# STERLING RANCH ROAD & BRIARGATE PARKWAY STORM PLANS

COUNTY OF EL PASO, STATE OF COLORADO  
STORM SEWER PLANS  
MAY 2022

# ENG-CDR22001-R3-CDs Storm.pdf Markup Summary

**POND GRADING PLAN**

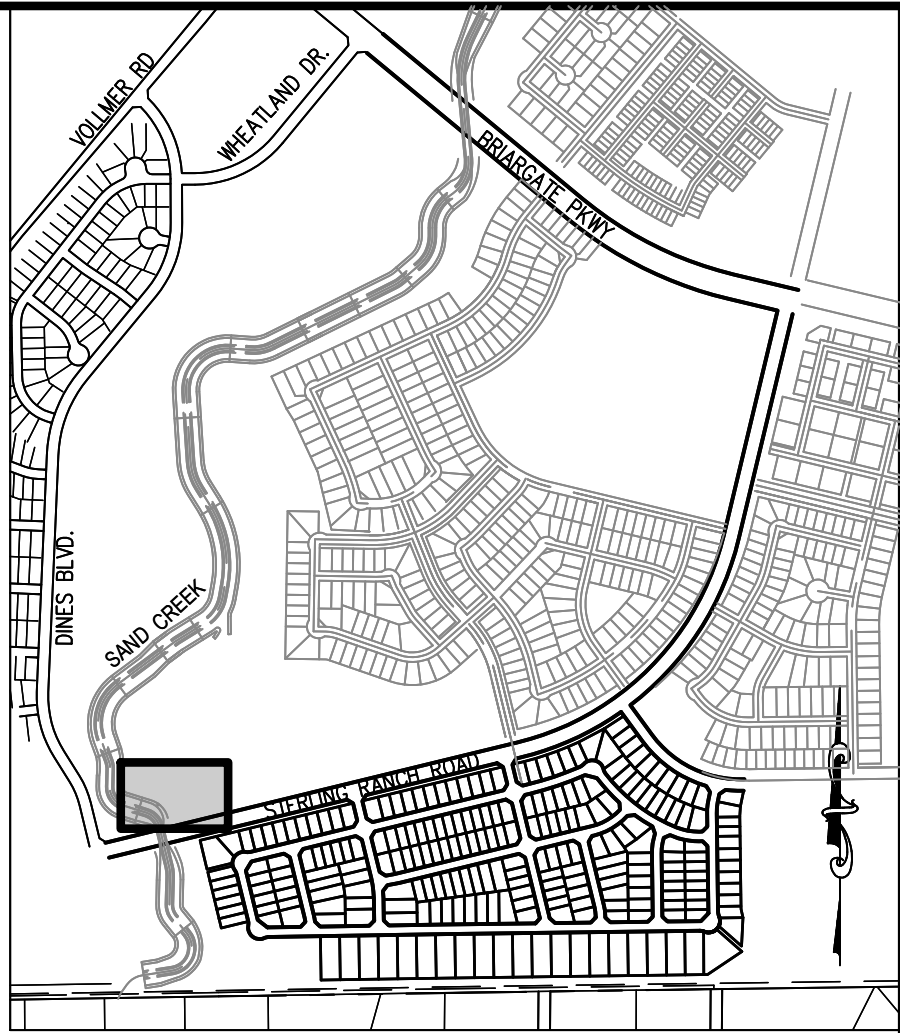
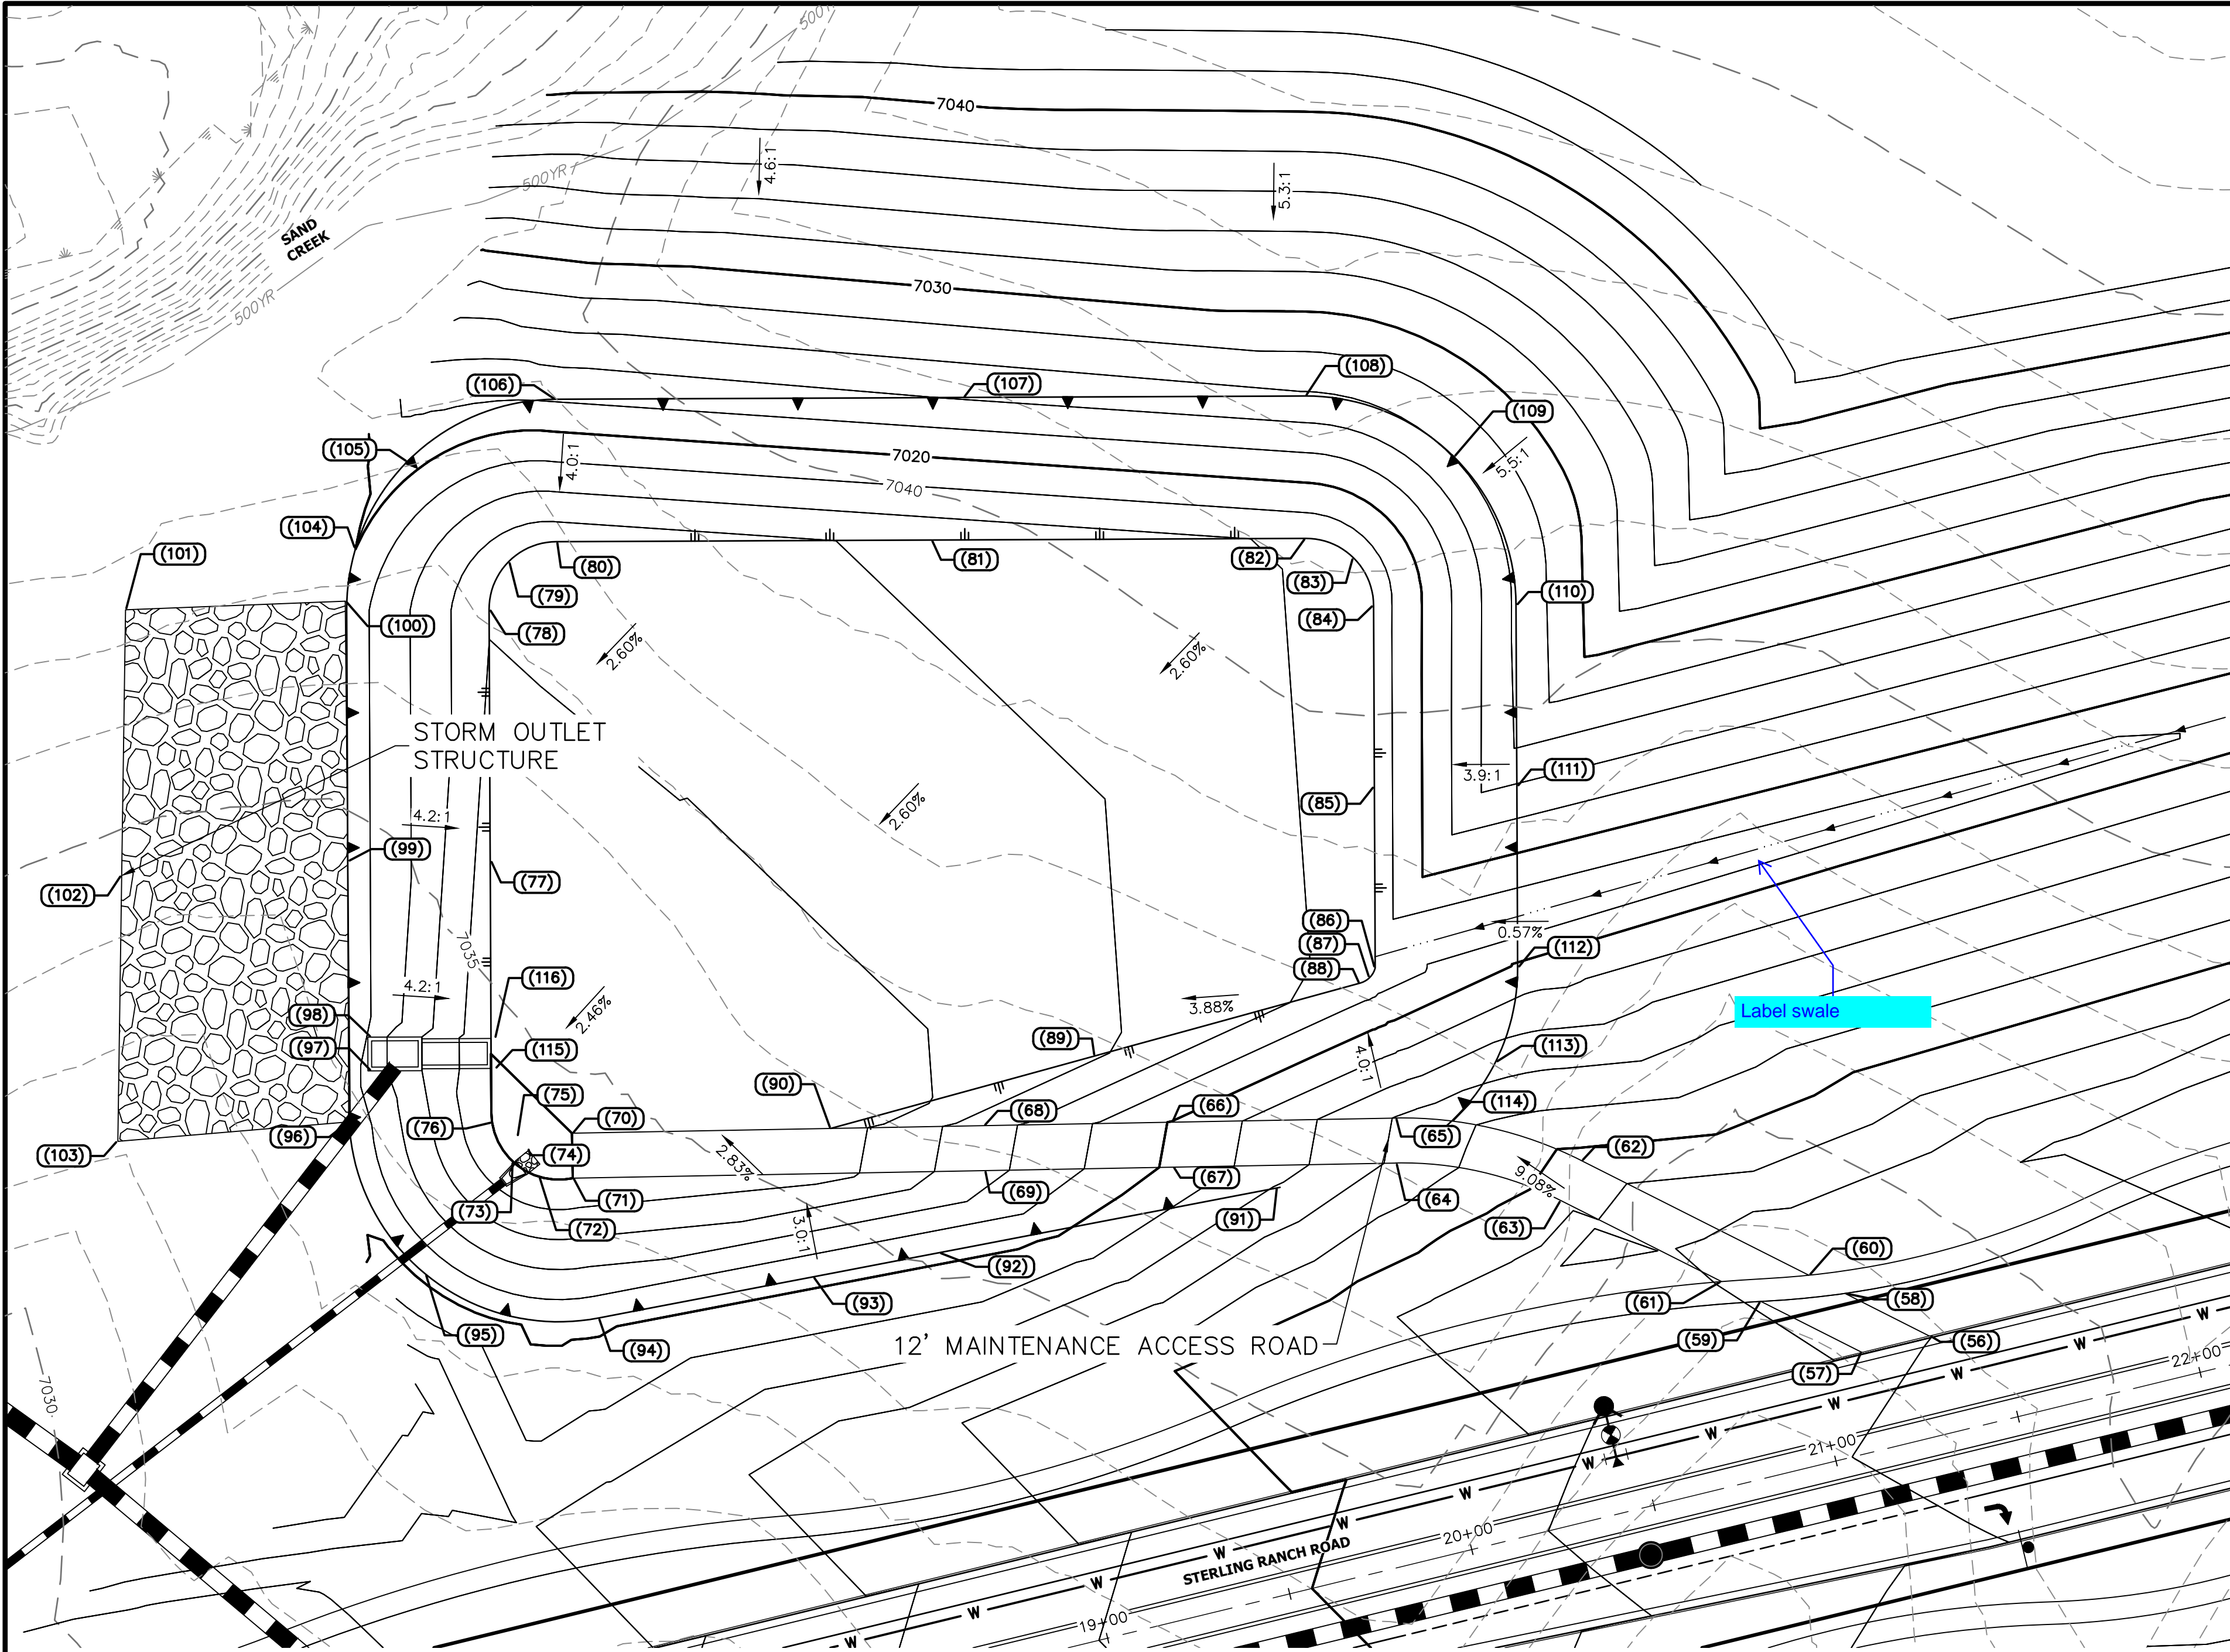
Include details for spillway & outlet structure
